COMMISSION DIRECTIVE

of 7 April 1987

adapting to technical progress Council Directive 84/538/EEC on the approximation of the laws of the Member States relating to the permissible sound power level of lawnmowers

(87/252/EEC)

Figure 1

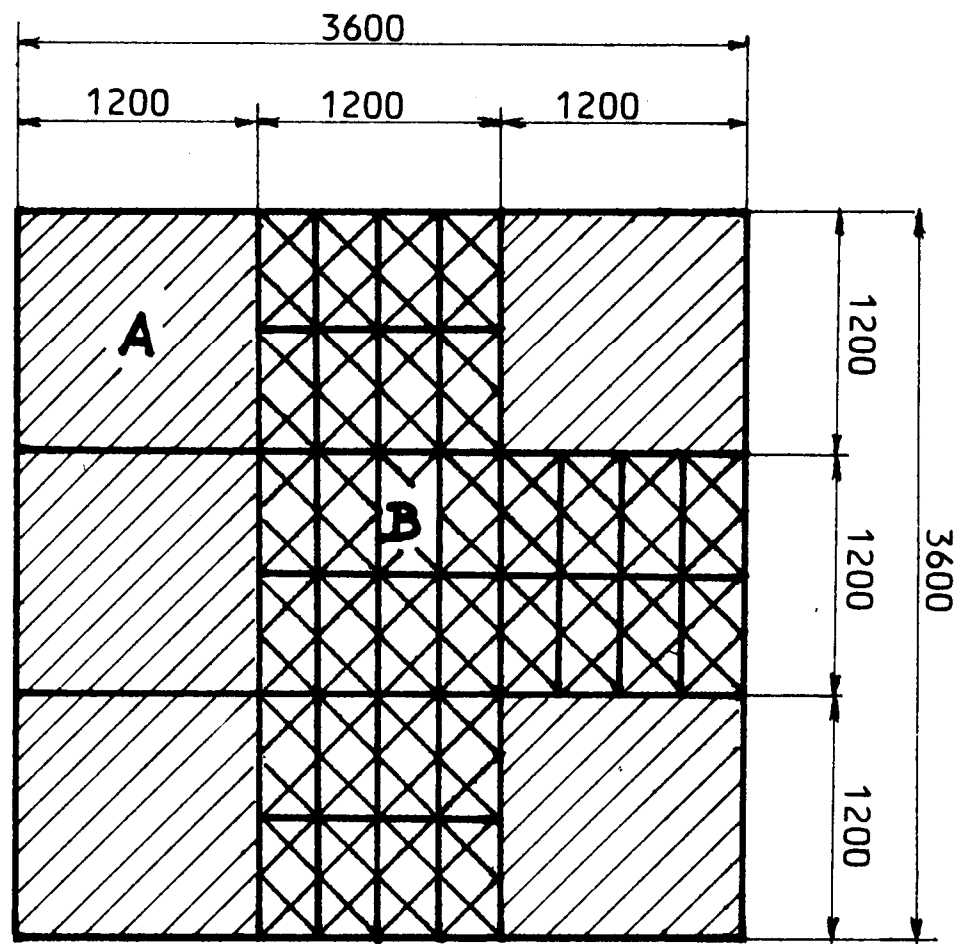
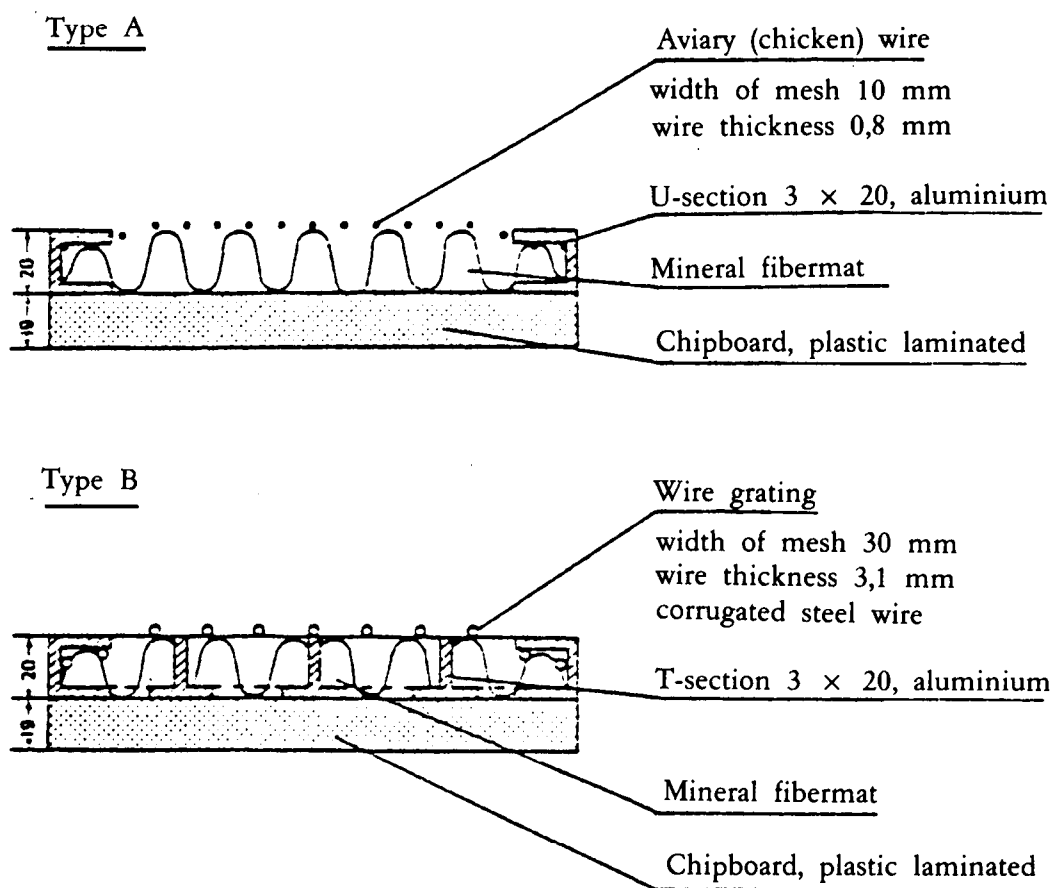
The outsides are bordered by aluminium U-sections of size 3 × 20 mm. In general, these joint planes come in two types :

(A) planes not to be loaded ;

(B) planes to carry the lawnmower and the staff.

On the joint planes mentioned under (B) aluminium T-sections size 3 × 20 mm are mounted as spacers (see Figure 1).

The prepared boards are then covered with the absorptive material cut to size.

The planes mentioned under (A) are covered with a wire mesh with a wire thickness of 0,8 mm and a mesh width of 10 mm (aviary wire).

The planes under (B) are covered with wire grating of corrugated steel wire with a diameter of 3,1 mm and a mesh width of 30 mm.

These wire covers are fastened to the aluminium U-sections.

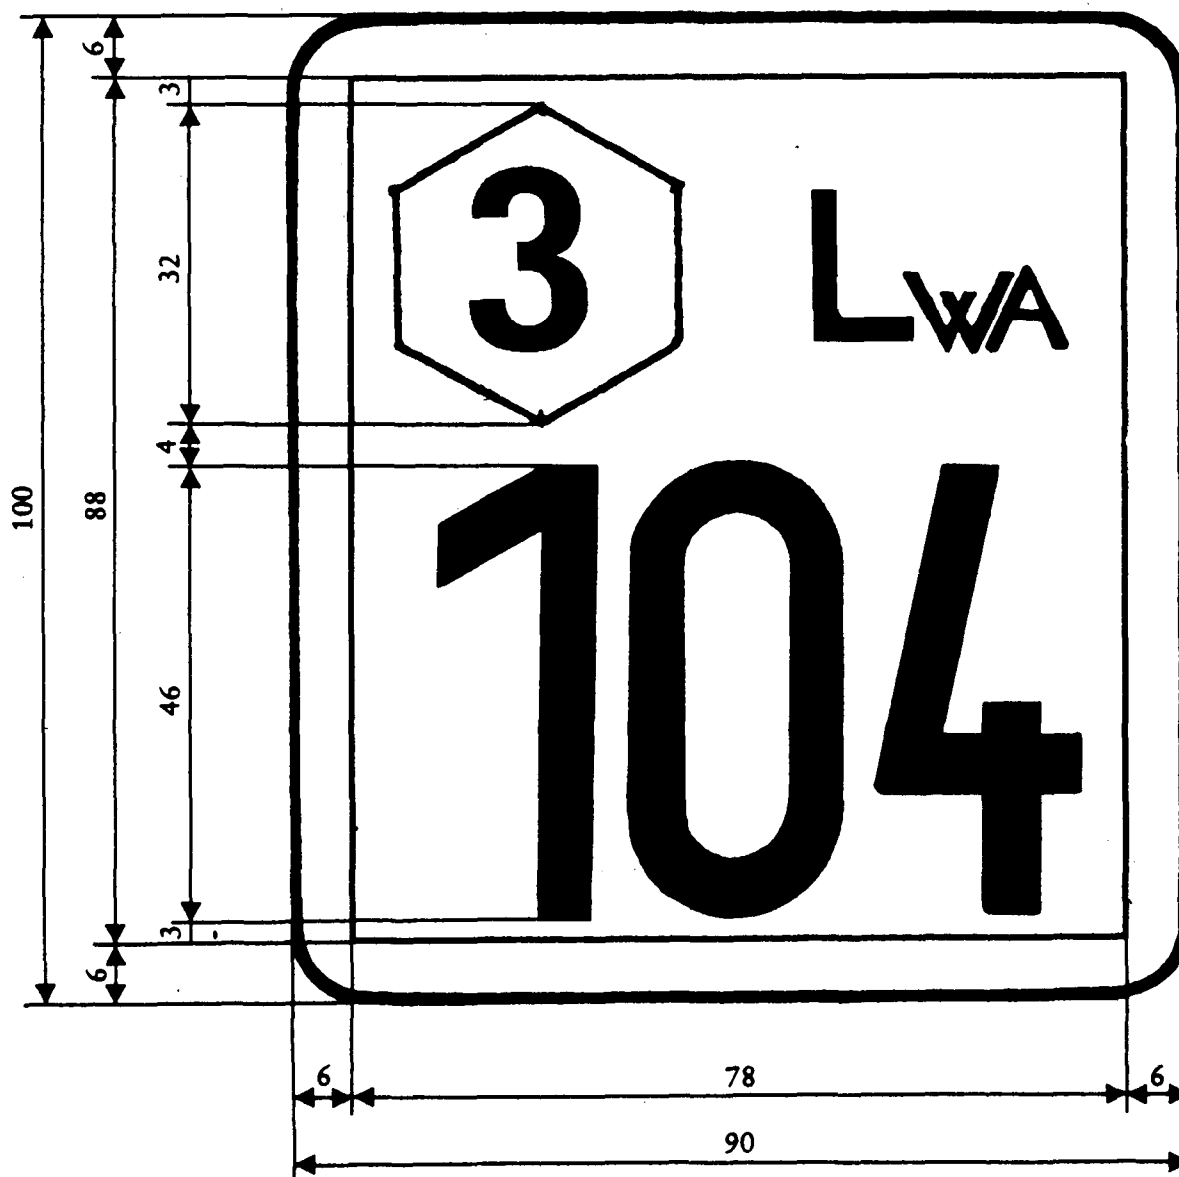
The model for Mark for Sound Power Level shall be replaced by the following model.

All the dimensions given may be multiplied, for example by 1/2, 1/3, 2, 3, 4, etc, on condition that the specifications laid down in Article 4 are adhered to.

A tolerance of 20 % shall be allowed on all the above dimensions.
